Southern California Dredged Material Management Team (SC-DMMT)
July 25, 2012
Final Meeting Notes

a. Ventura Harbor Maintenance Dredging (Inner and Outer) (POC: Antal Szijj):

VENTURA PORT DISTRICT, PROPOSED SAMPLE LOCATIONS FOR AREA C

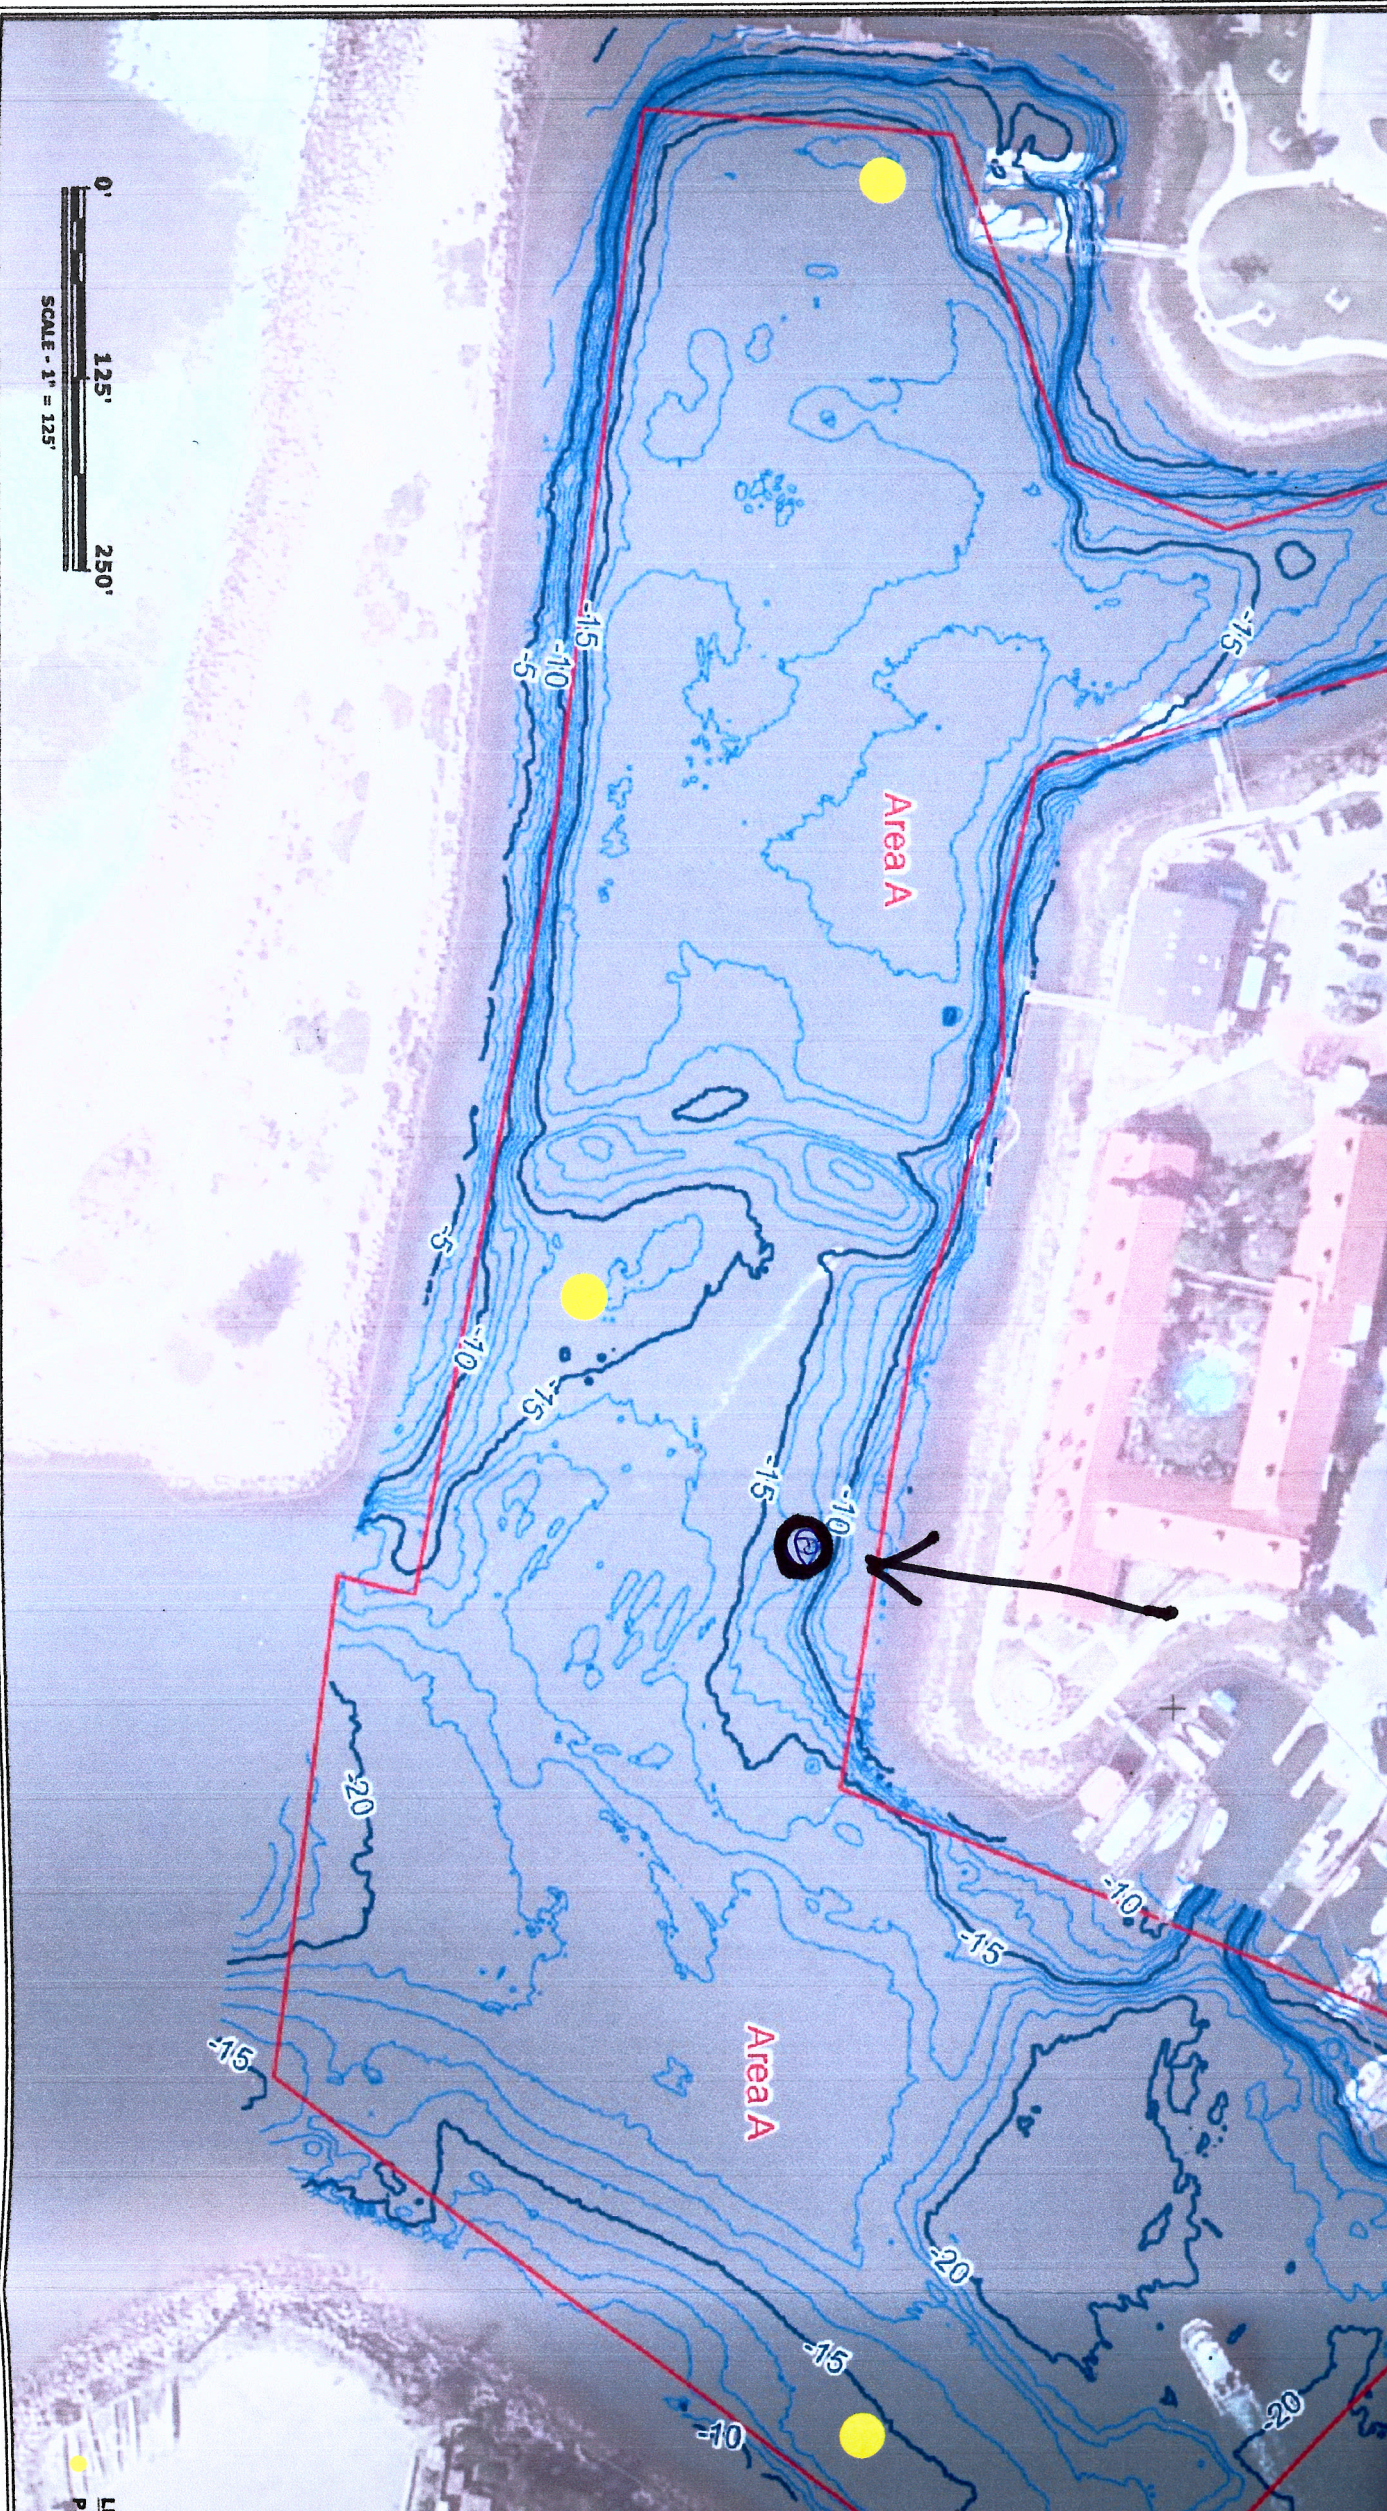
- i. EPA, RWQCB: Pyrethroids and PCB congeners should be added to the analyte list.
- ii. Corps:
 - 1. Plate 2: dredge unit (text) labels should be legible.
 - 2. Add north arrows to all figures.
 - 3. SAPs should describe how core samples will be archived.
- iii. EPA:
 - 1. Connecting channel SAP, task 1, page 2: clarify number of core samples.
 - 2. Add two new core locations (marked up figures attached).
 - 3. Table for dredging volumes includes area F, but text states area F won't be dredged. May need clarification.
- iv. Ventura: Harbor: one core was moved in response to Coast Keeper and Heal the Bay input (plate D5, upper right corner, area C).
- v. RWQCB, EPA, Corps, CCC: SAPs acceptable once above changes incorporated and revised documents submitted to agencies.
